Application under the Agricultural Operation Practices Act for a confined feeding operation, manure collection area, and/or manure storage facility(ies)

<b>NRCB USE ONLY</b>	Application number <b>LA25064</b>	Legal land description <b>SW 26-11-23 W4M</b>
<input checked="" type="checkbox"/> Approval <input type="checkbox"/> Registration <input type="checkbox"/> Authorization <input type="checkbox"/> Amendment

**Re:               Geotechnical Review and Evaluation  
                  NRCB Permitting of Pens & Catch Basin  
                  SW-26-011-23-W4M, near Nobleford, Alberta**

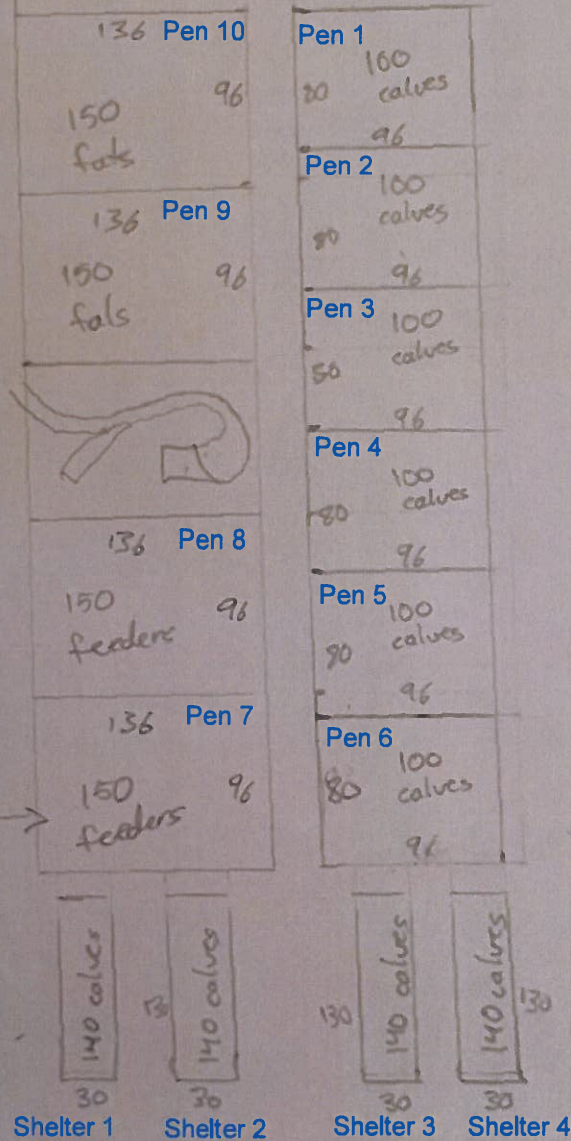
Catch basin permitted  
by Approval LA25040 -  
not yet constructed

AO note: Approval LA25040 permitted the new CFO 250' from Range Road 232. This application seeks to amend the location of the CFO 50' to the west to 200' from the road.
